OLD BEGA HOSPITAL
ARTS & CULTURAL CENTRE

DESIGN DEVELOPMENT
29.03.2018

REVIEW OF FEEDBACK ITEMS

GALLERY

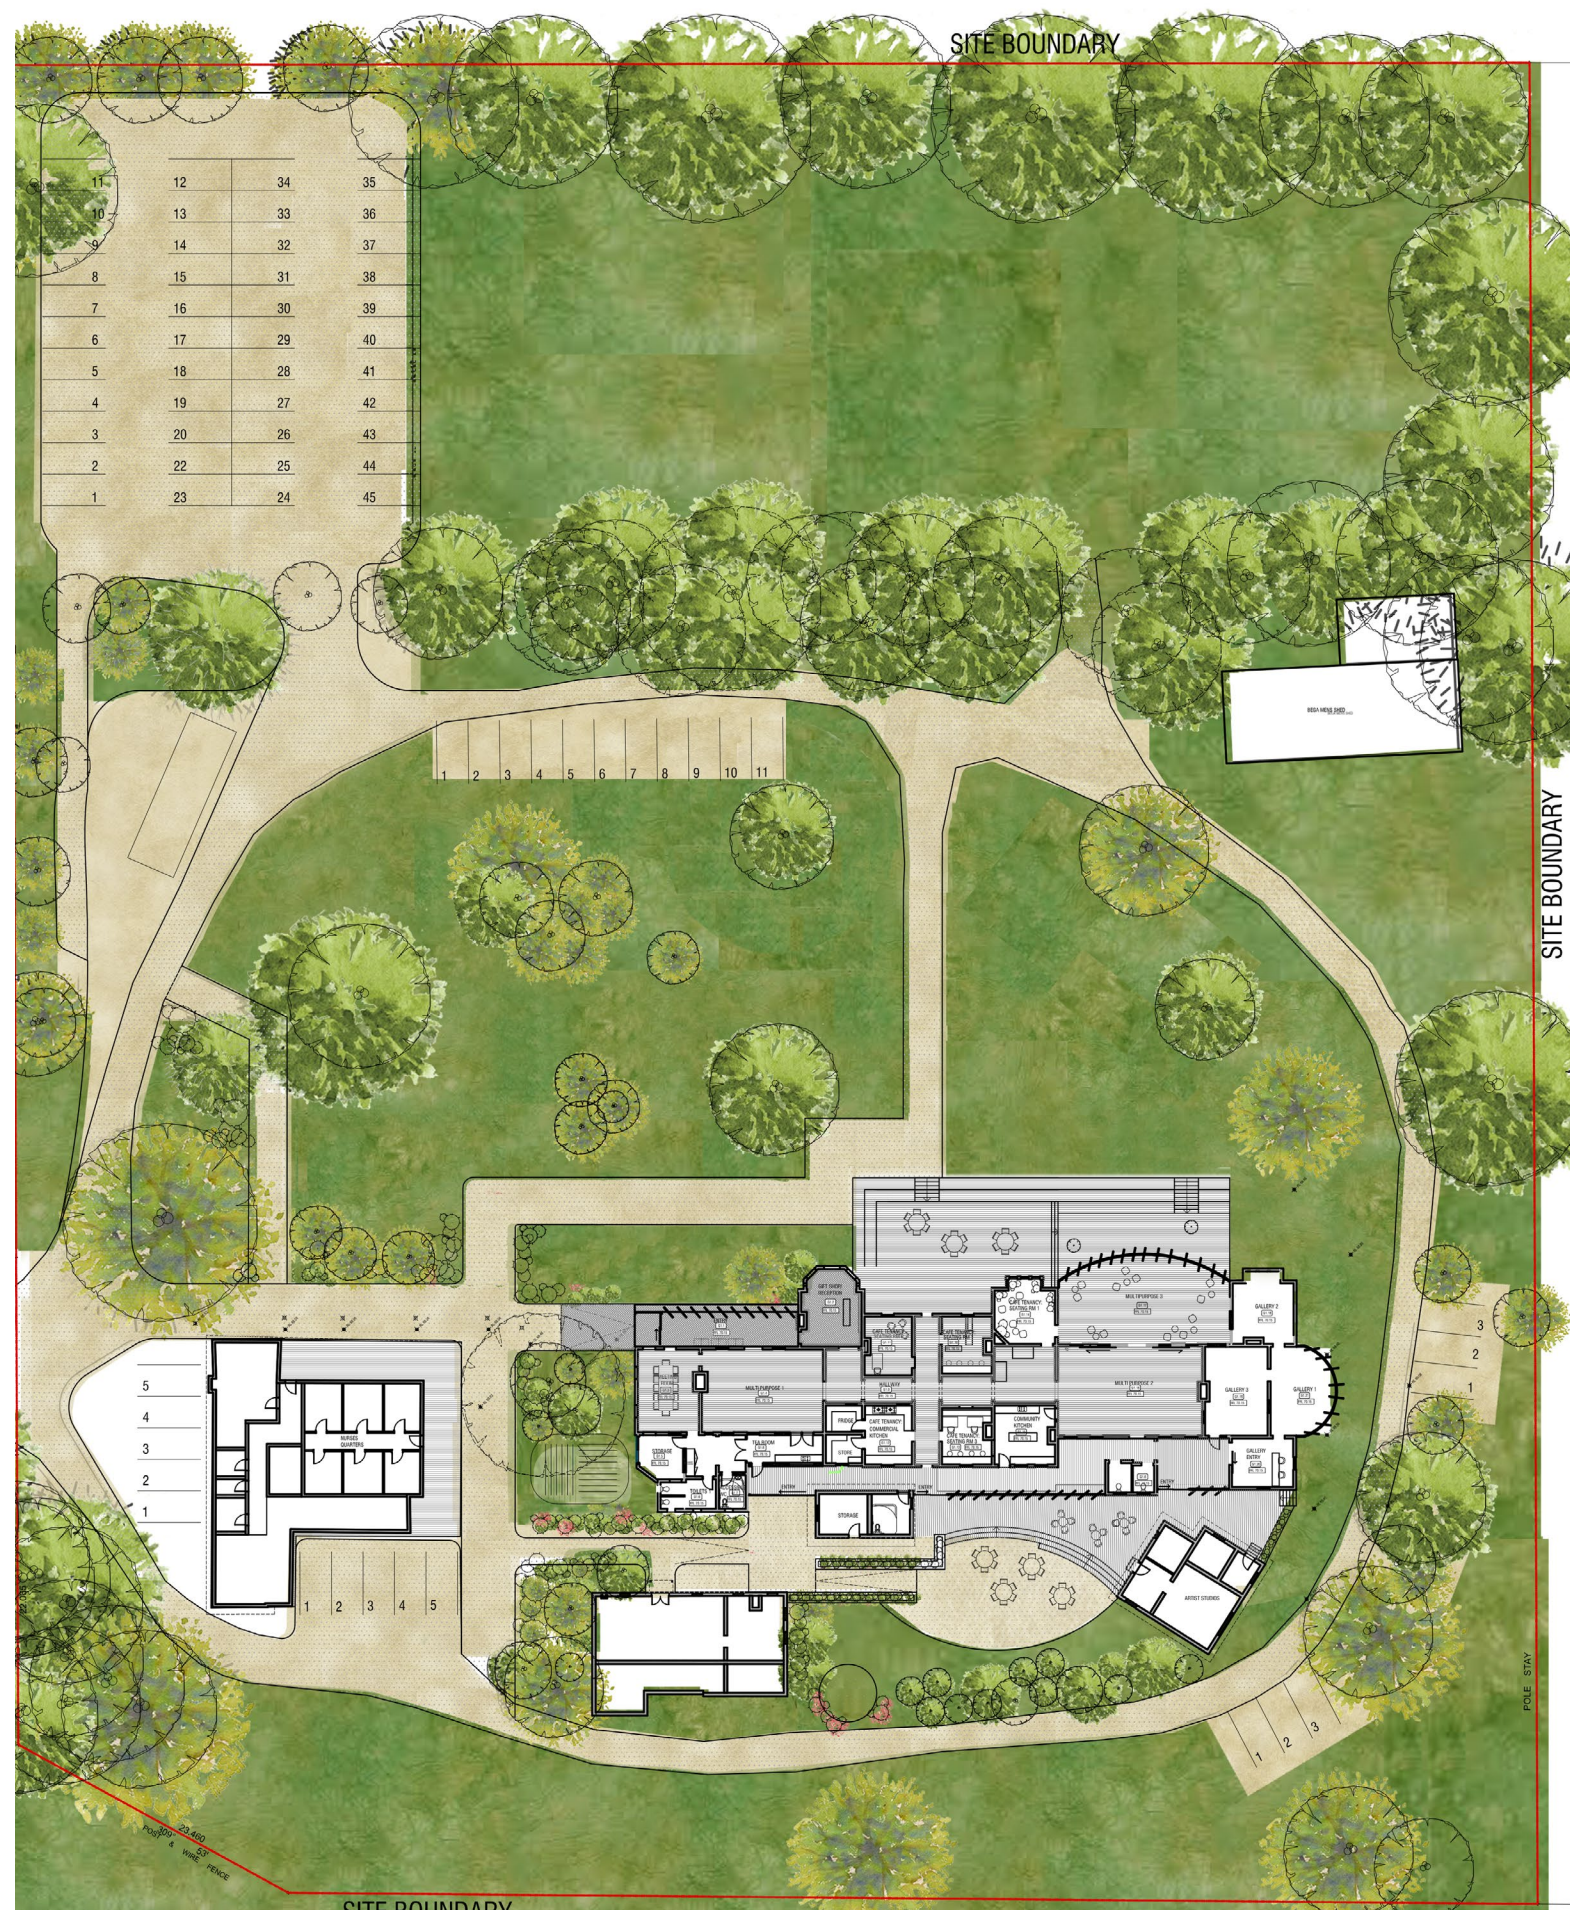
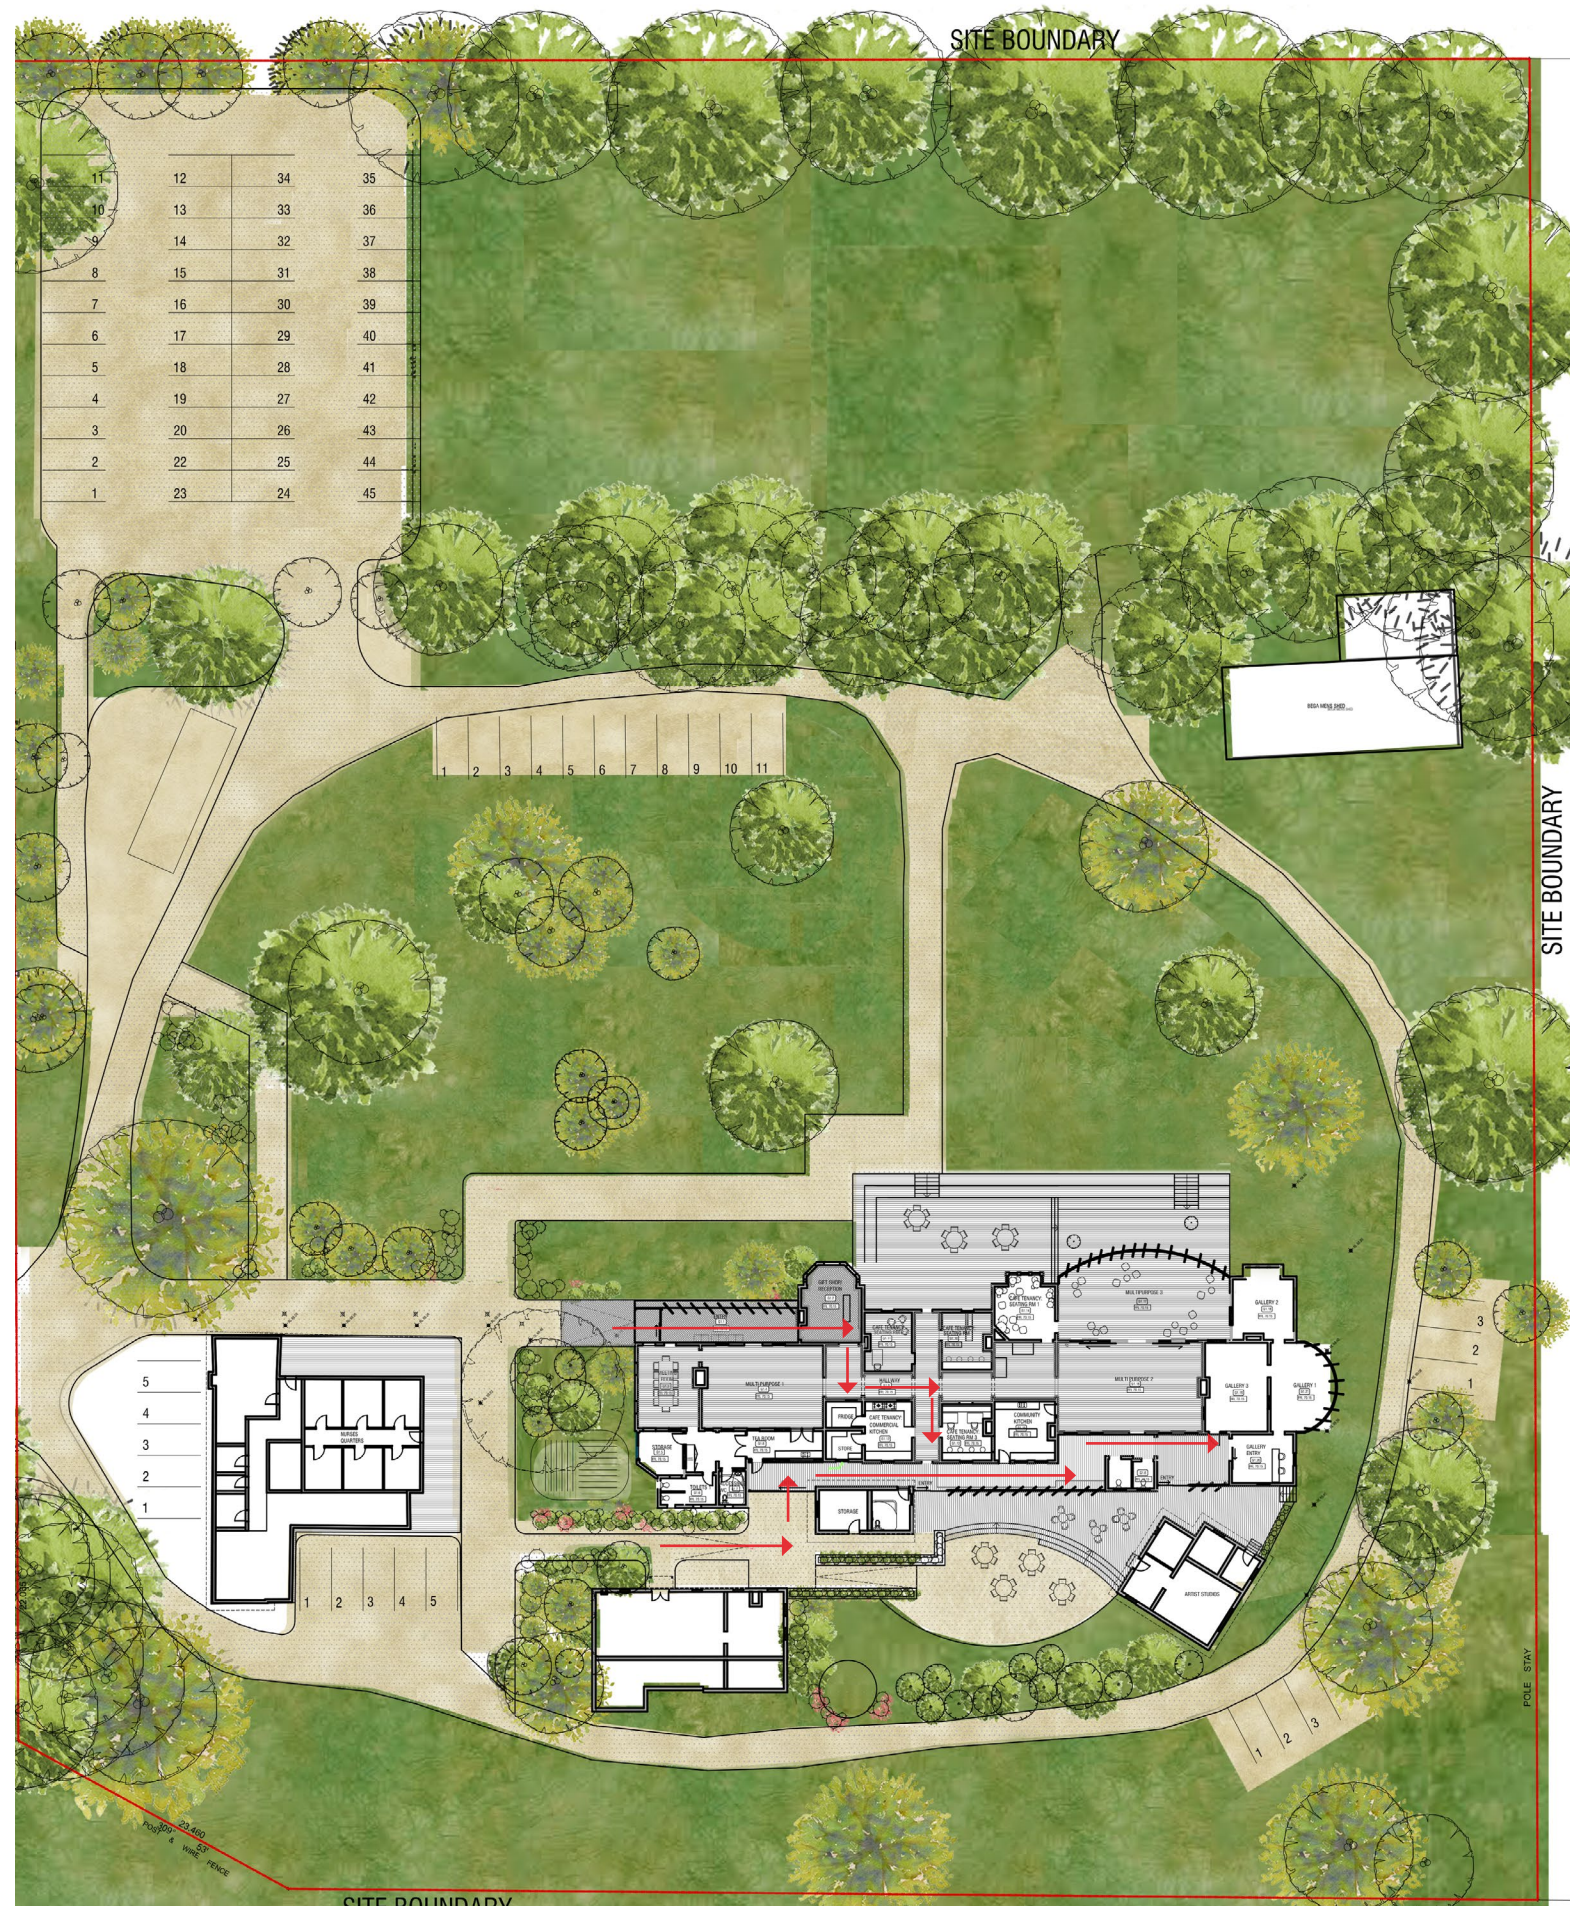
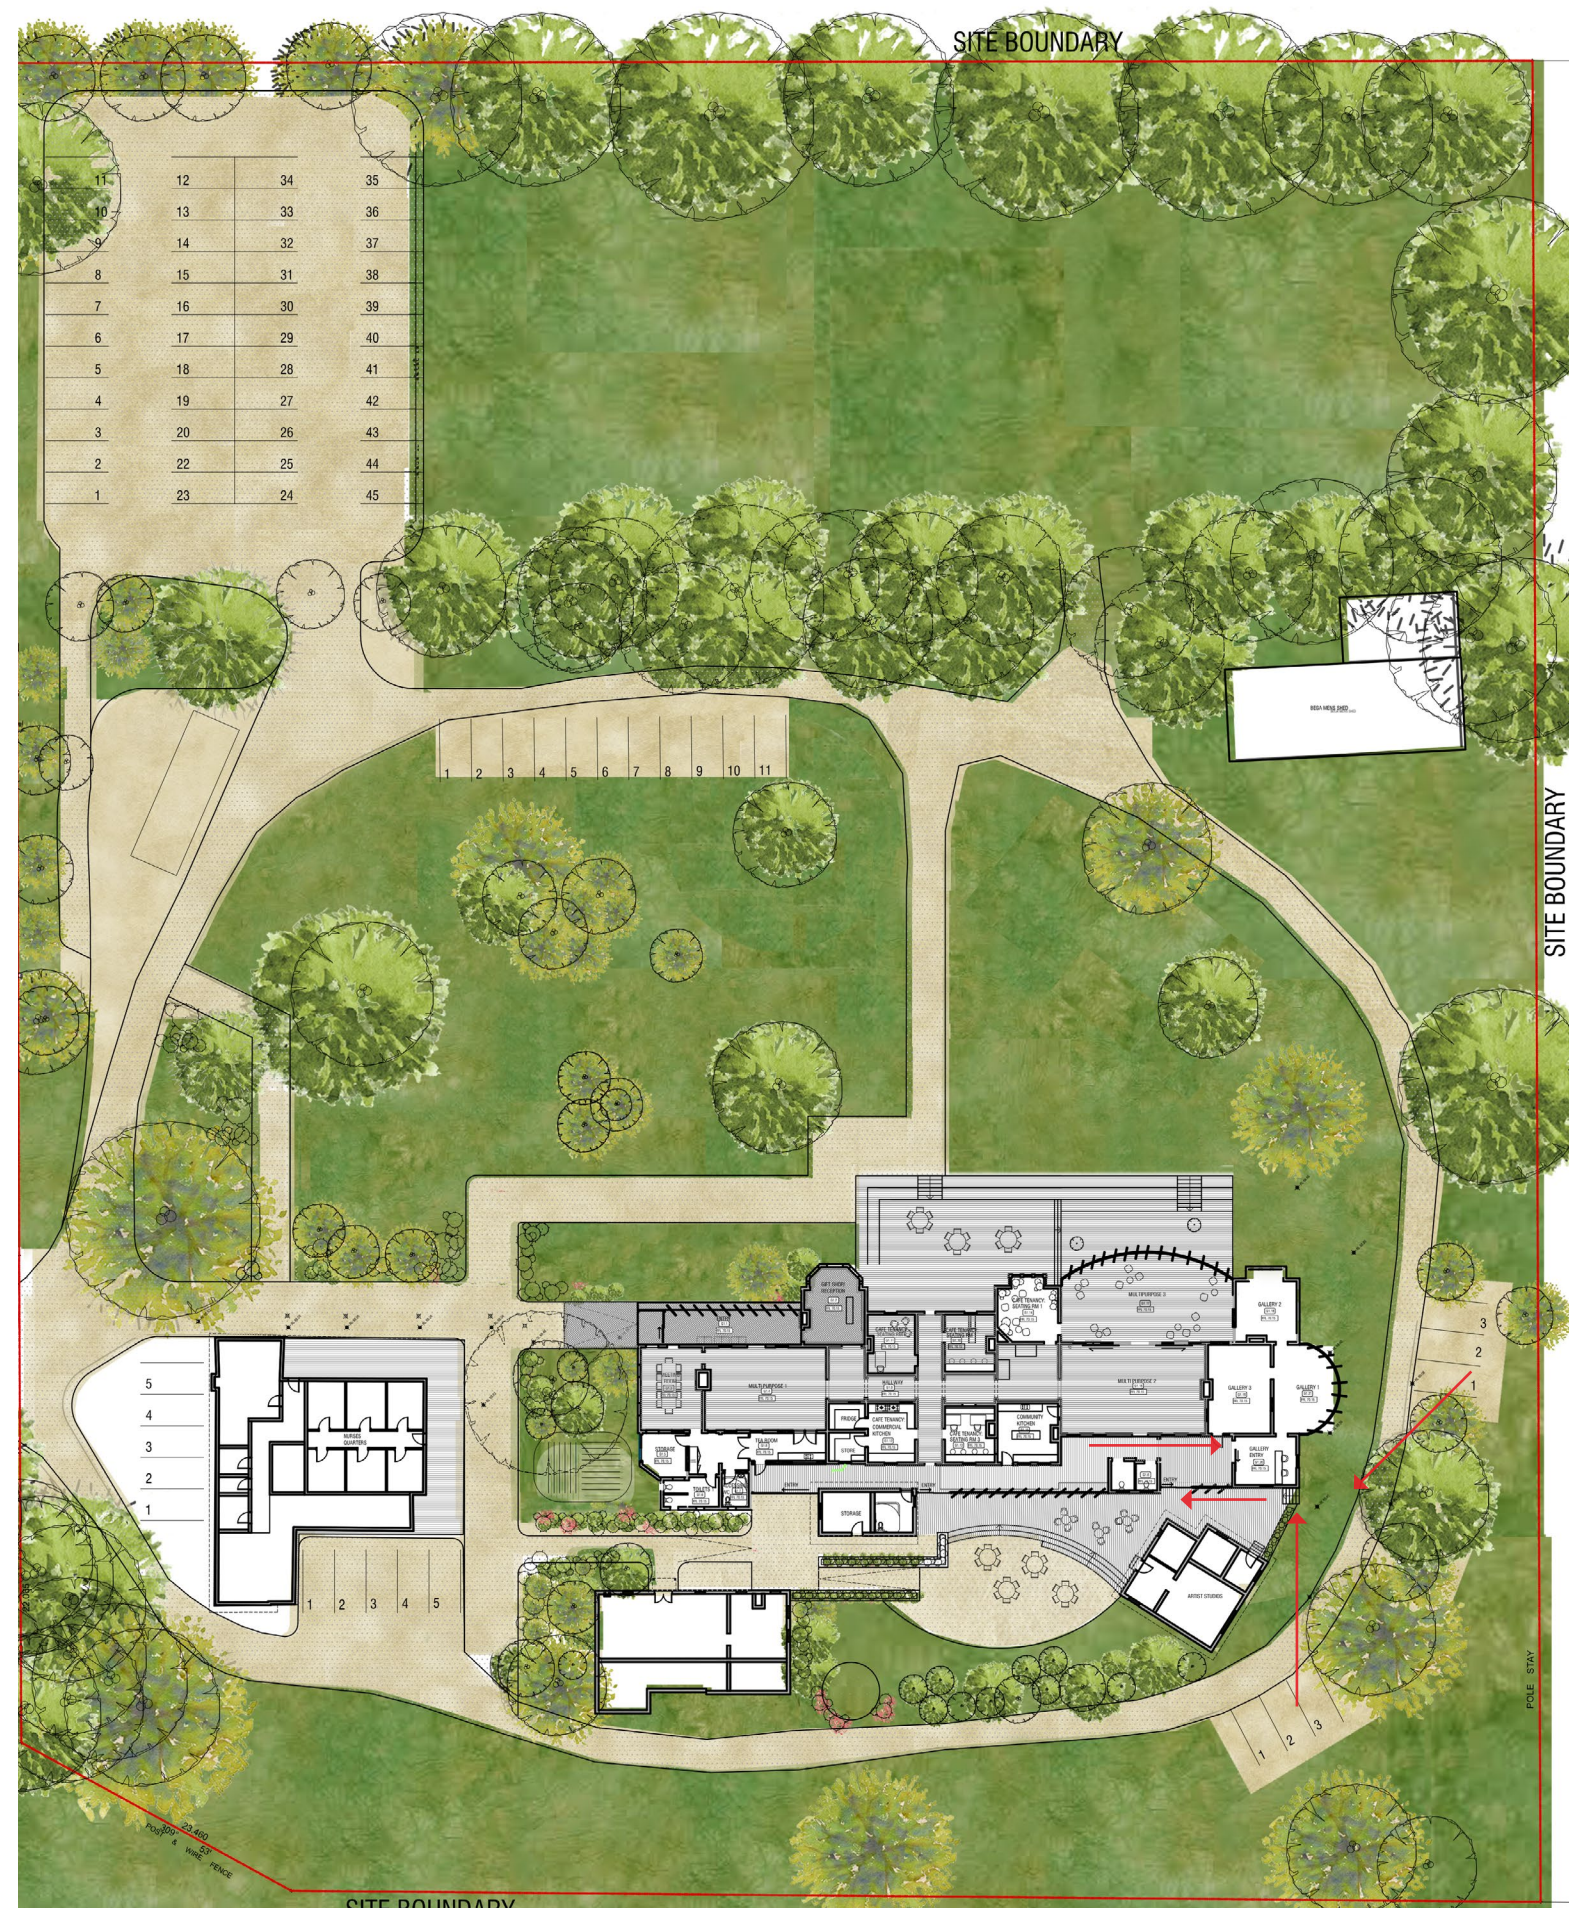
5. THE GALLERY VERANDAH IS NOT SHOWN TO HAVE OPERABLE GLASS PANELS. WHAT IS INTENDED?
6. WE CONSIDERED WHETHER THERE WAS ENOUGH ACCESS FROM THE MAIN BUILDING INTO THE GALLERY SPACES
